To: Plan Holders for Improvements to the  
Washington County Airport  
Mineral Point, Missouri  
MoDOT Project No. 24-060A-1 & 24-060A-2

Transmitted herewith is **Addendum No. 1** to the Issued for Bid Contract Documents, Specifications and Plans dated May 28, 2024, for Improvements to the Washington County Airport.

**ADDENDUM NO. 1  
TO  
CONTRACT DOCUMENTS, SPECIFICATIONS AND PLANS  
FOR IMPROVEMENTS TO THE  
WASHINGTON COUNTY AIRPORT  
MINERAL POINT, MISSOURI  
MODOT PROJECT NO. 24-060A-1 & 24-060A-2**

EROSION CONTROL PLAN STA. 8+40 TO 13+60 OS 180' R RUNWAY 2/20		SHEET NAME C814	
MoDOT PROJ. NO. 24-060A-1 & 24-060A-2	WOOLPERT PROJ. NO. 1015274	SHEET NO. 126 of 145

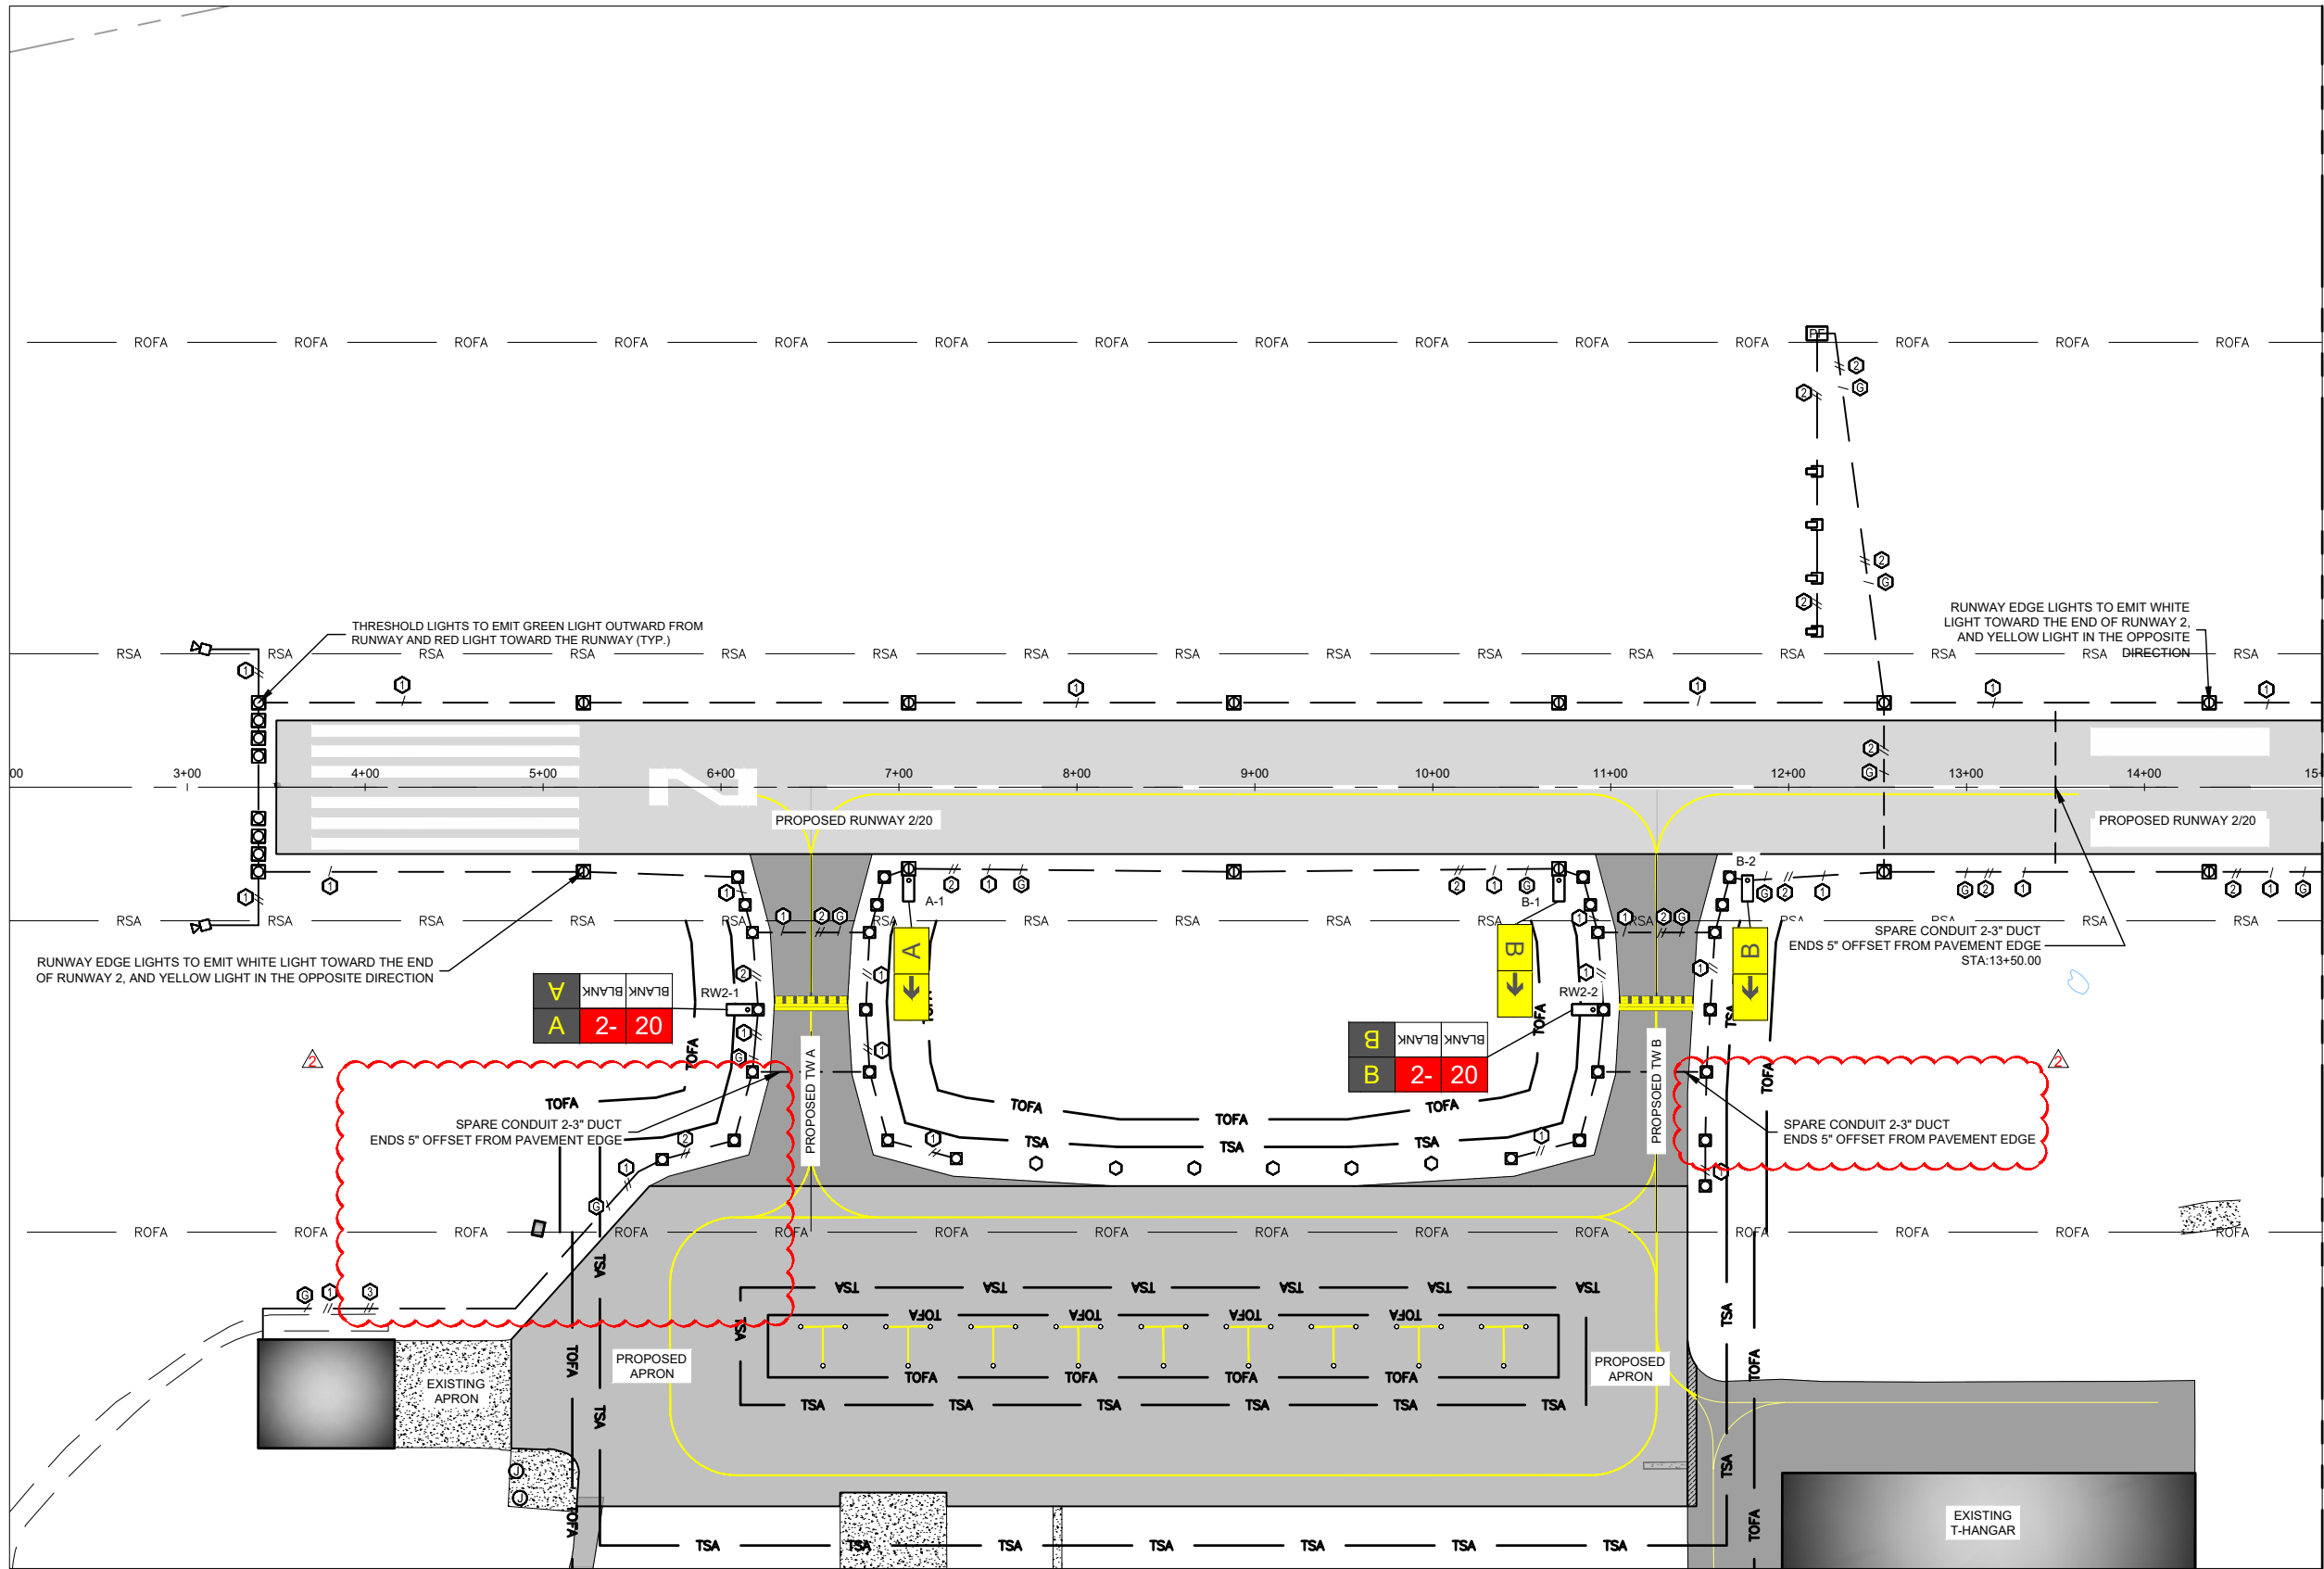
**C814 - (126 of 145) Erosion Control Plan, STA. 8+40 to 13+60 OS 180' R, Runway 2/20**
